SEWAGE DISPOSAL SYSTEM

A REPAIR

SUBDIVISION _____ LOT _____ ROAD 7915 Old Jessup Road

Re: **NOTICE OF VIOLATION**
Overflowing Septic System
7915 Old Jessup Road

SITE INSPECTION SHEET

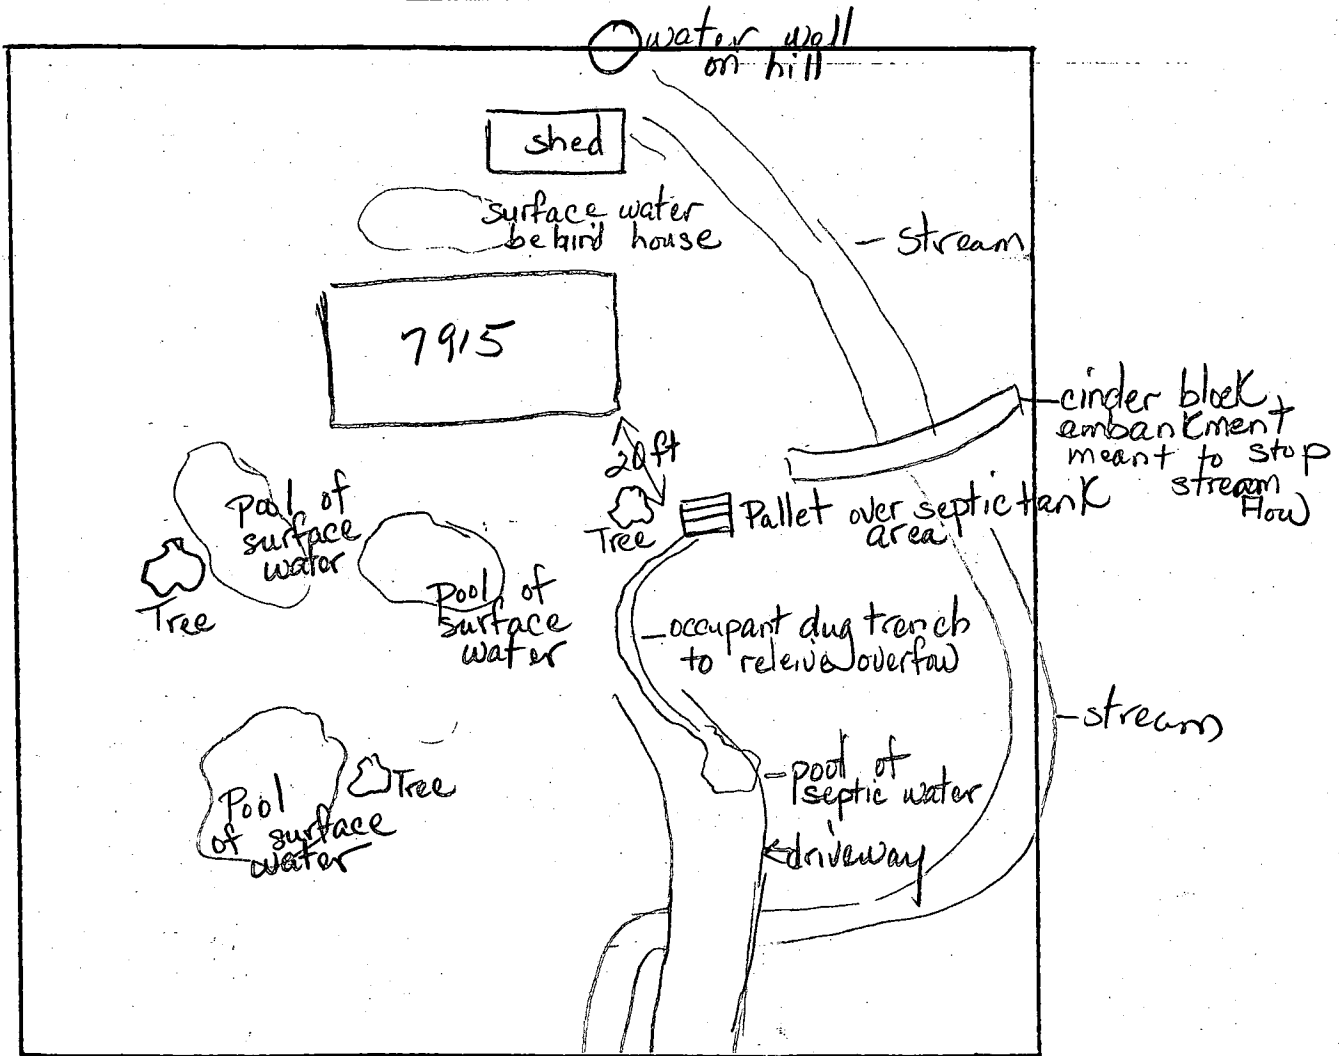
PROPOSAL: Over-flowing septic Mrs. Scheuer states
Complaint she's a widow

COMMENTS: 4-10-91 spoke to Jean Reed
Property has no R.O.W to allow
The house is lower than road and
is 400 to 550 ft off of Old Jessup
Road. JEN

Bureau of Engineering
connection to public sewer
cannot be sewerred. House
DB
